TO: U.S. Department of Energy
Office of Nuclear Energy, Response to IPC
1000 Independence Ave SW.
Washington, DC 20585
consentbasedsiting@hq.doe.gov

FR: Donna Gilmore
SanOnofreSafety.org
San Clemente, CA
dgilmore@cox.net
949-204-7794

RE: Response to IPC – DOE's CIS Nuclear Waste Plan Risks Major Radioactive Leaks

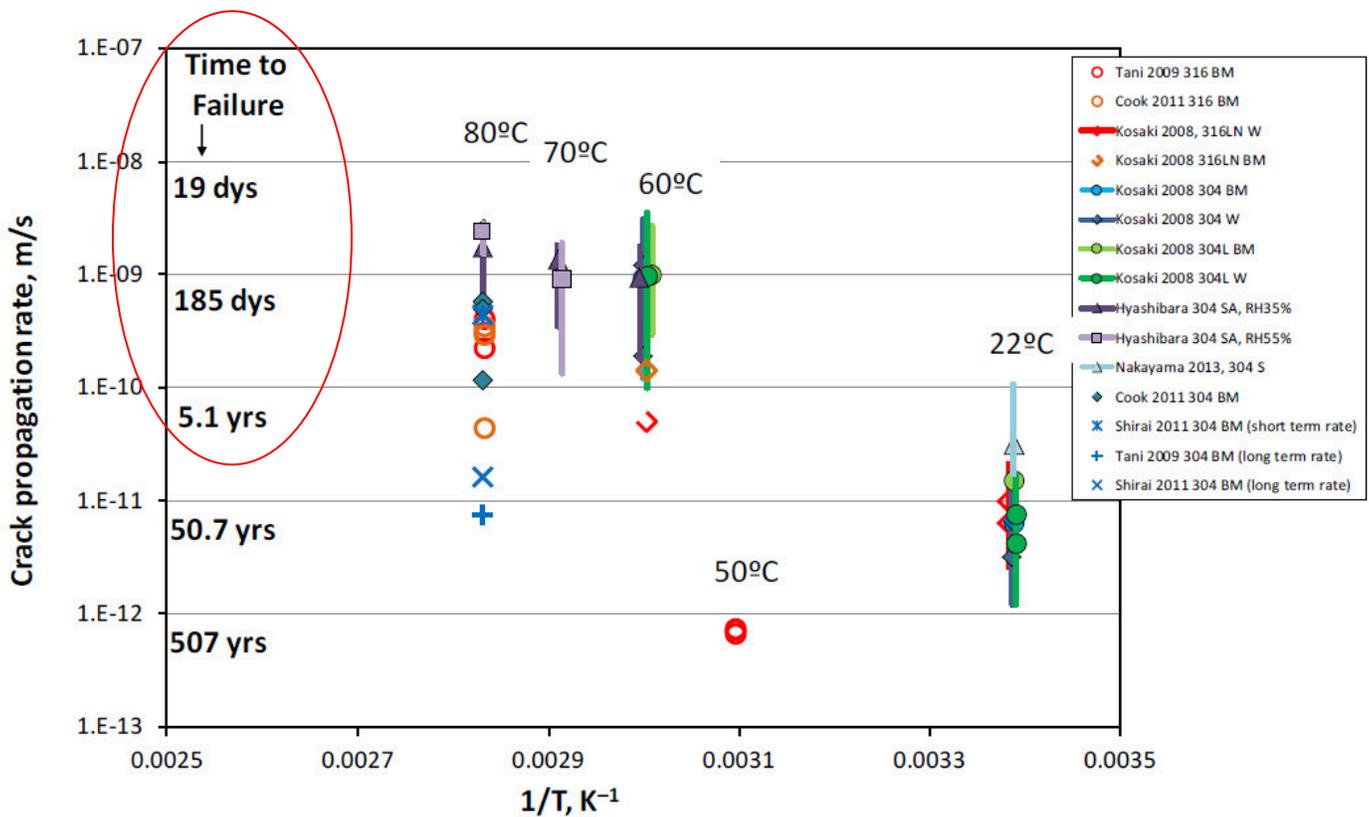
Thin-walled stainless steel U.S. irradiated spent fuel storage canisters at higher temperatures will have faster crack growth rate. The Sandia Chart below shows higher temperatures can cause canisters to penetrate the wall in less than 5 years. This chart assumes canister wall is 0.625” (5/8”) thick. The majority of the U.S. canisters are only 0.50” (1/2”) thick. It is unknown when a crack will start, but these canisters are subject to corrosion and cracking from environmental conditions such as chloride salts, air pollution (sulfides), pitting, and microscopic scratches. The report states that canisters such as those at Diablo Canyon have temperatures in these heat ranges.
